Customer Service Bulletin Commercial Business Group

Multi Pro[®] Hose Reel Kit

Date: Nov. 17, 2004

Subject: Water may collect in the Hose Reel Switch Box.

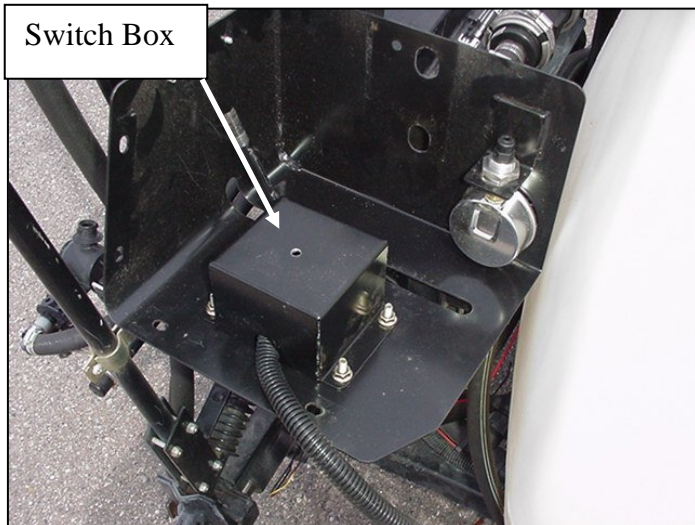
Water may infiltrate the Switch Box (106-1322-03) during cleaning or periods of outside storage. Water that collects in the box has no way to drain. Eventually this could fill the Switch Box and may result in electrical malfunction.

Remove the Switch Box and drill a .250 (7mm) hole in the bottom-center of the box. Refer to the instructions below for further information.

- Remove the mounting screws and knob. (circled Items)
- Remove the cover and turn over.

- Remove the four Switch Box retaining screws and remove the Switch Box.
- Drill a .250 (7mm) hole in the bottom-center of Switch Box as shown.

Note: Do Not Drill without removing the Switch Box or damage to the switches could result.

- Reassemble in the reverse order.
